CONSTRUCTION SUMMARY OF EXTRAS

Site: CALEDON (B)

15B

Model: Purchaser: GLENN ABBEY (30-01) B

PARTIAL SECOND FLOOR PLAN ELEV. 'C'

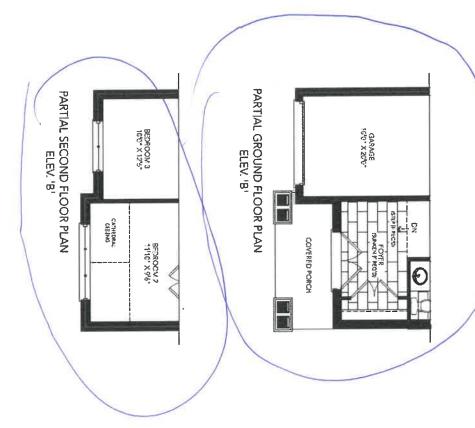
DESCRIPTION
20	MASTER ENSUITE -ADD BANK OF DRAWERS
21	MASTER ENSUITE - COMFORT HEIGHT VANITY
22	MASTER ENSUITE - FLOOR TILES UPGRADE 2
23	MASTER ENSUITE -UPGRADE 2 TILES ON SHOWER WALL
24	MASTER ENSUITE - RECTANGLE UNDERMOUNT SINKS (X2)
25	MAIN BATH - ADD BANK OF DRAWERS
26	N/A
27	BATHROOM ACCESSORIES - UPGRADE TO MOEN METHOD IN ALL BATHROOMS (X3)
28	POWDER ROOM - UPGRADE 1 CABINETS
29	POWDER ROOM - RECTANGLE UNDERMOUNT SINK
30	CREDIT - FOR RELCOATION OF 3 PCE ROUGHIN THAT COULD NOT BE MOVED DUE TO GRADE
31	NOTE: SEE NEW LOCATION FOR LAUNDRY SINK IN BASEMENT **CENTRE IN BASE AREA OF UNIFINISHED SPACE (REVISED FROM STRUCTURALS)
